CoreLink™
DDR2 Dynamic Memory Controller (DMC-341r1)
Errata Notice

This document contains all errata known at the date of issue in releases up to and including r1p0 of PL341 AXI DDR2 Dyn Mem Ctrl, and revision r1p1 of DMC-341 AXI DDR2 DYN MEM CTRL

466779: DDI0418B DDR2 DMC (PL341) r0p1 TRM - Figures show incorrect timing**Status**

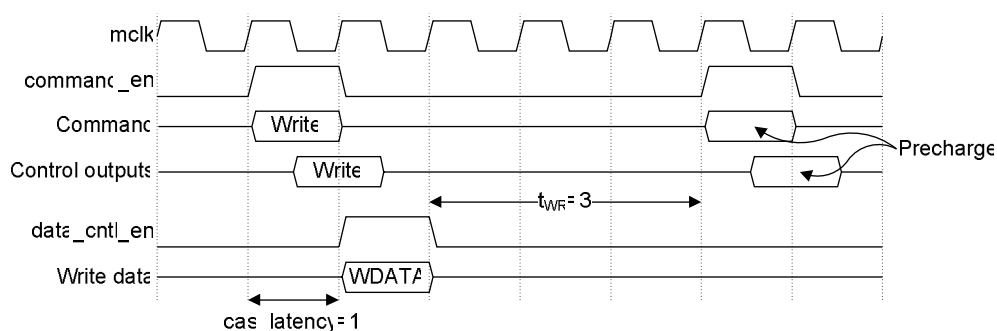
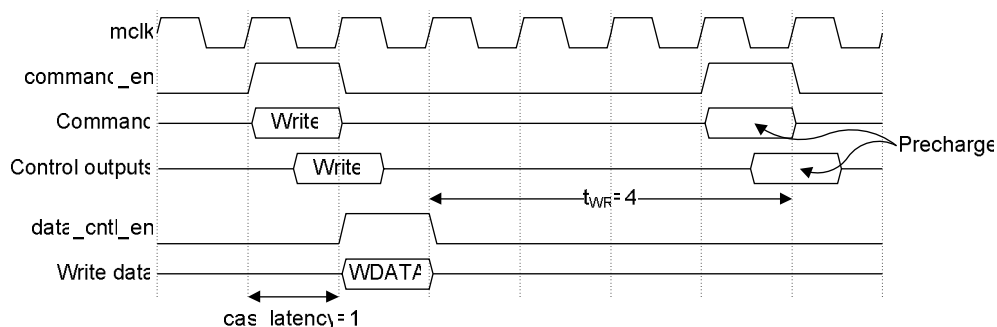
Some of the timing diagrams in the the Technical Reference Manual do not show correctly how a timing parameter is applied.

The numerical value shown for the timing paramater does not correspond with the timing of the signals shown in the diagrams. In each case, the numerical value should be one higher than the timing shown, and the arrow should be extended to the next rising clock edge.

For example the existing diagram Figure 2-19:

Figure 2-19 Data output timing, write latency = 2

Should be displayed as:
